IN THE DRAWINGS:

REMARKS

William Infantolino, et al
(RAK) END920010110US1
1/2

Figure 1
(Prior Art)

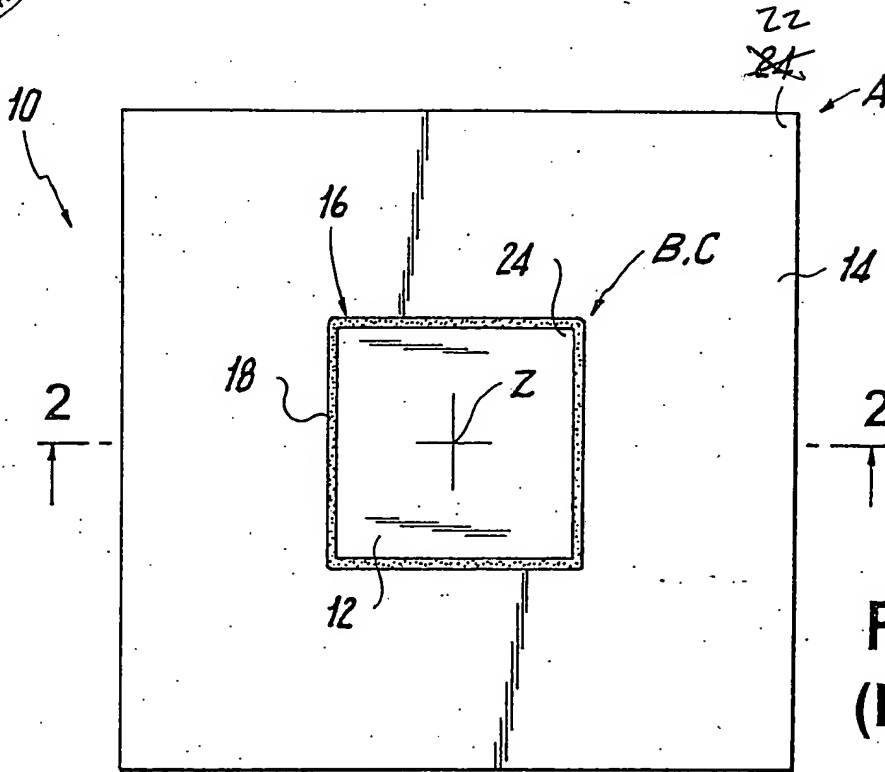
Furthermore, with regard to the drawings, applicants herewith enclose a Replacement Sheet and an Annotated Sheet for Figures 1-3 indicating the corrected reference numerals in Figures 1 and 3, which should read "22" in lieu of "24" at the edge portions of the component 14. This should clearly meet all of the requirements with regard to formal matters.
